STAFF REPORT

REFERENCE: RM070086, RM070087, RM070238, NN980291V1 and NN010266V1

SUBJECT: **RIWAKA FRUIT AND VITICULTURAL SERVICES - REPORT EP07/07/01** - Report prepared for 2 July hearing.

The property is located on Flett Road, Lower Moutere.

Resource Consent
Application Plan

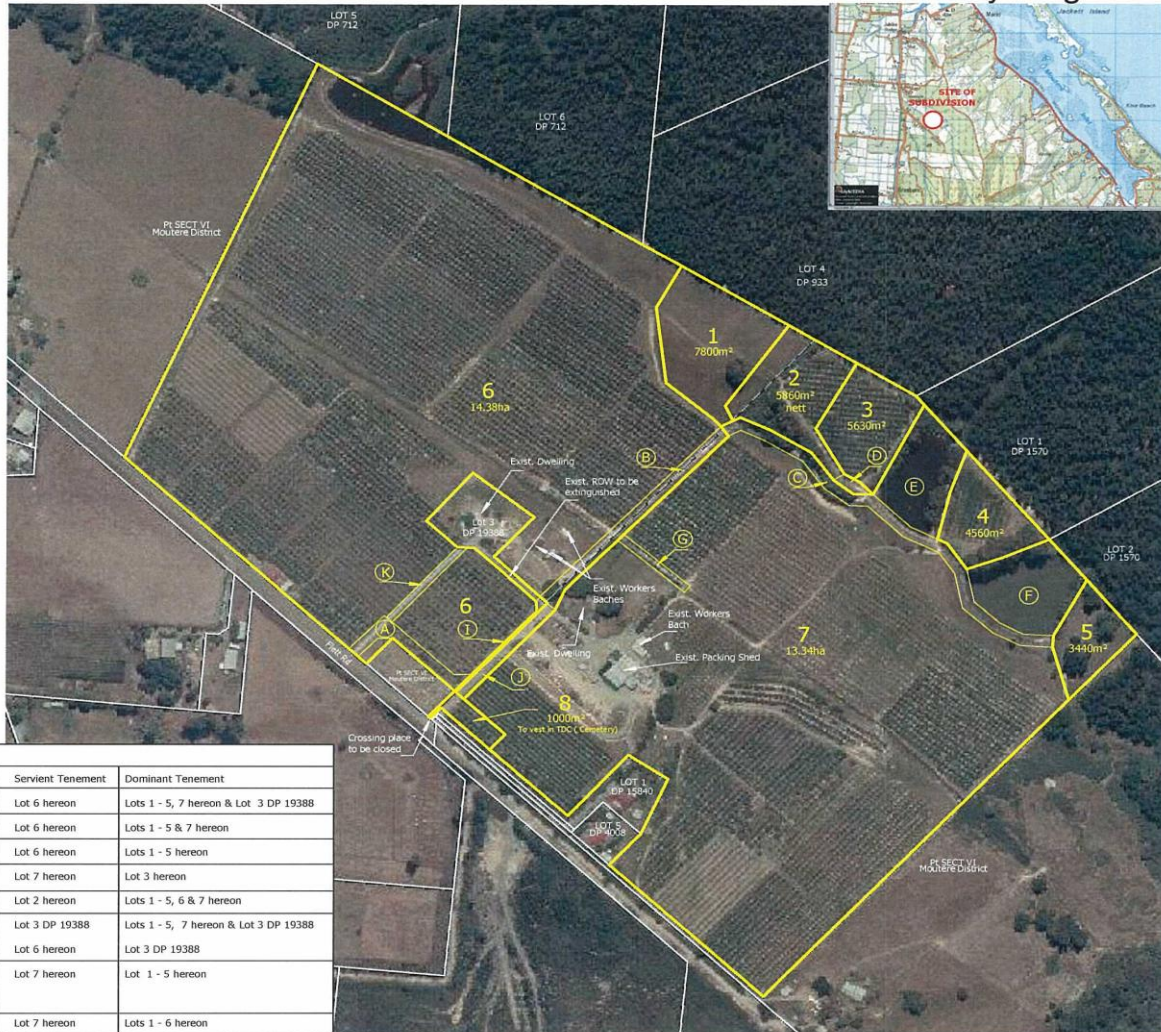
The subdivision shall be completed in accordance with the Staig & Smith Plan 8835 dated 20/6/2007 submitted with the application.

- v) The route of the right-of-way AB shall be as per Staig & Smith Plan dated 20/6/2007, which has the right-of-way well away from Lot 2 DP 19338.
